RESOLUTION MODIFYING THE GEARY CORRIDOR BUS RAPID TRANSIT LOCALLY PREFERRED ALTERNATIVE TO RELOCATE THE WESTBOUND TRANSITION FROM CENTER-RUNNING TO SIDE-RUNNING BUS-ONLY LANES ONE BLOCK WEST, TO THE BLOCK BETWEEN 27TH AND 28TH AVENUES

Addendum to Environmental Impact Report

Project Title: Geary Corridor Bus Rapid Transit Project

Proposed Modification: Outer Richmond Transition Area

Figure 2. Hybrid Alternative Bus Lane Configuration Change between 26th and 28th Avenues Proposed in the Final EIS

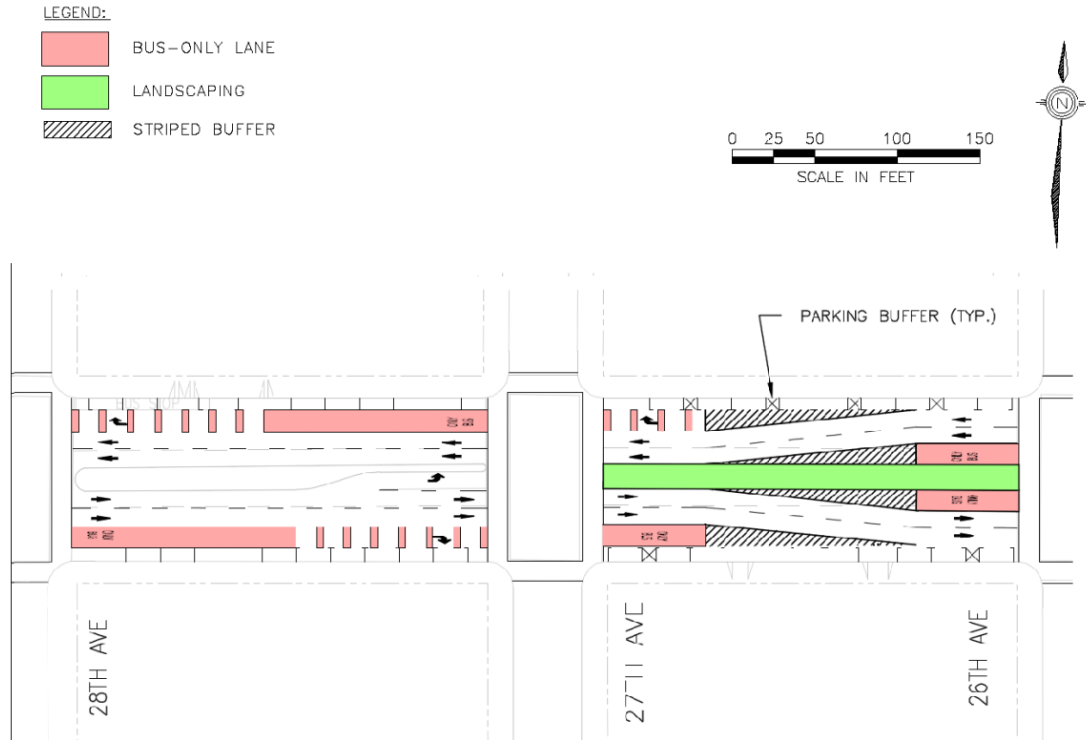
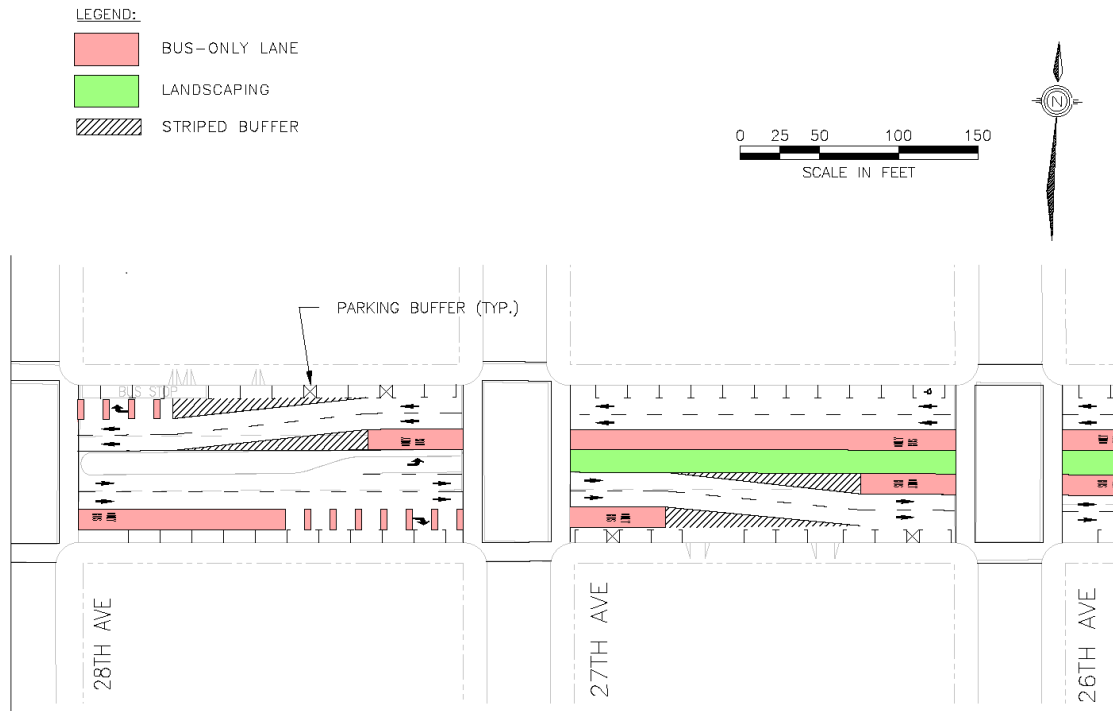
The Project as described in the Draft EIS/EIR and Final EIR assumed a transition from center- to side-running bus lanes in the Outer Richmond neighborhood between 26th and 27th Avenues (see Figure 1). As shown in Figure 1, both eastbound and westbound buses were proposed to transition to or from center/side-running lanes between 26th and 27th Avenues.

As proposed in the Draft EIS/EIR and Final EIR, this design would eliminate nine of the 18 existing angled on-street parking spaces on the north side of Geary between 26th and 27th Avenues due to a combination of the conversion of existing angled spaces to parallel spaces and installation of buffer areas between spaces. On the north side of Geary between 27th and 28th Avenues, the design as proposed in the Draft EIS/EIR would add one parallel parking space to the existing seven parallel parking spaces (eight parallel spaces would result).

The northern side of the block between 26th and 27th Avenues is occupied by the Holy Virgin Cathedral (6210 Geary Boulevard), a religious and community facility. To better accommodate the parking and loading concerns of the facility, the agencies have proposed to modify the transition, as shown below in Figure 2.

As shown in Figure 2, the *westbound* transition would shift one block to the west, to the block between 27th and 28th Avenues. In other words, the center running bus lane would continue for one additional block west. Buses would therefore transition from center running to side running lanes between 27th and 28th Avenues.

No parking buffer areas would be installed on the north side of Geary (immediately adjacent to the Cathedral) between 26th and 27th Avenues, thus preserving two additional parking spaces (retaining 11 of the existing 18 spaces). With this design, the number of parking spaces remaining on the north side of Geary between 27th and 28th Avenues would not change relative to the project as proposed in the Draft EIS/EIR and the Final EIR: a total of eight parallel spaces, an increase of one space over existing conditions.

The *eastbound* transition would remain as proposed in the Draft EIS/EIR and Final EIR, between 26th and 27th Avenues on the south side of Geary Boulevard. No modification to the eastbound transition is proposed.

To achieve the proposed modification depicted in Figure 2, the following changes to roadway striping aspects of the approved project would be necessary.

- Additional red roadway coloring (denoting a bus-only lane) in the westbound innermost (closest to center) lane for approximately one third of Geary between 27th and 28th Avenues.
- Striping of parking buffers on the north side of Geary between 27th and 28th Avenues, instead of between 26th and 27th Avenues as previously proposed, resulting in the provision of two additional parking spaces between 26th and 27th Avenues.

Prior to the proposed modification, the westbound transit signal queue jump was to have been located at 26th Avenue; eastbound, the queue jump was to have been at 27th Avenue. With the proposed modification, both transit signal queue jumps would be located at 27th Avenue. Based on analysis conducted by SFMTA, this change in queue jumps would not require any change to pedestrian signal timing at either 26th or 27th Avenues. Indeed, the consolidation of both queue jumps to one intersection would allow for more efficient signal coordination.

RESOLVED, That the Transportation Authority hereby modifies the Geary BRT LPA to relocate the westbound transition from center-running to side-running bus-only lanes one block west, to the block between 27th and 28th Avenues.

Figure 3: Proposed Construction Phasing

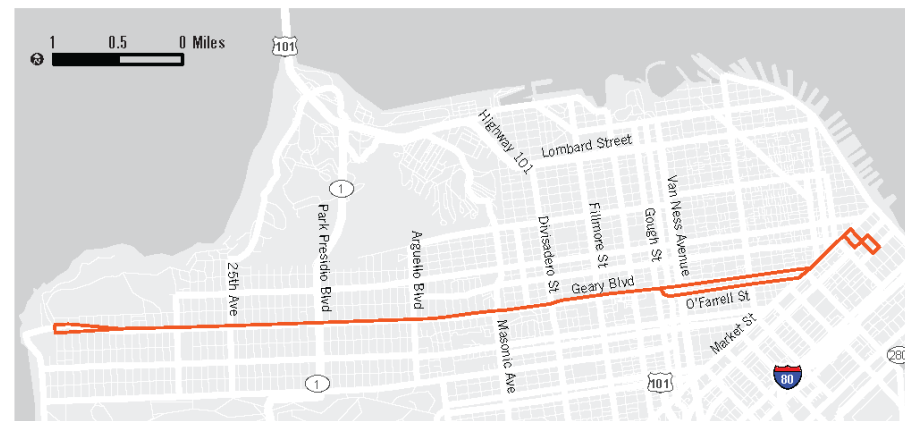
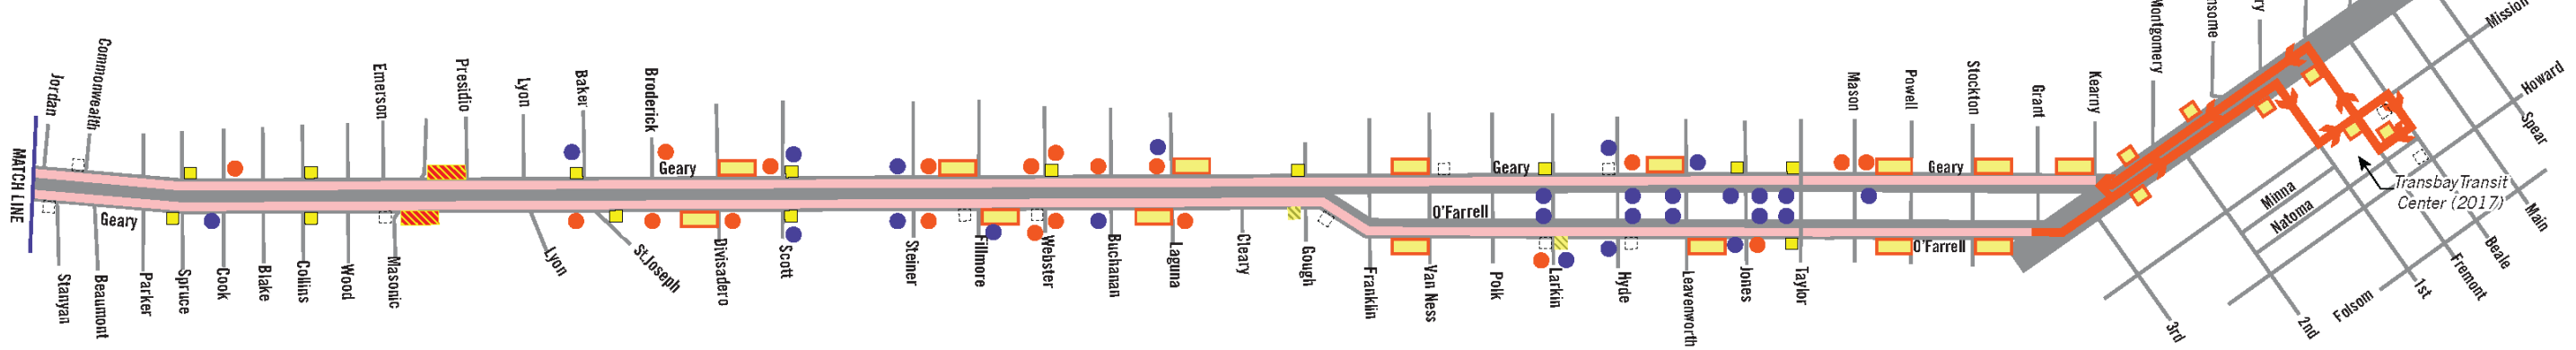
As illustrated in Figure 3 below, Phase I would entail work east of Stanyan Street where BRT would operate in side-running bus-only lanes. Phase II would include work west of Stanyan Street, where BRT operations would be in predominantly center-running bus-only lanes.¹ The project would still be constructed using the Staggered Multiple Block Segment Approach described in Section 4.15 of the Draft EIS/EIR.

Phase I and Phase II would *each* be expected to take approximately 100 weeks, including both active and inactive periods and anticipated separate utility work. With more information now available with regard to specific phasing activities and SFMTA's recent experience with similar projects, the duration of construction activities on any given block could take up to 12 months for areas with a larger scope of work inclusive of active and inactive periods, depending on construction scheduling, construction operations, and the extent of the utility work involved. The majority of blocks would have a shorter anticipated construction duration.
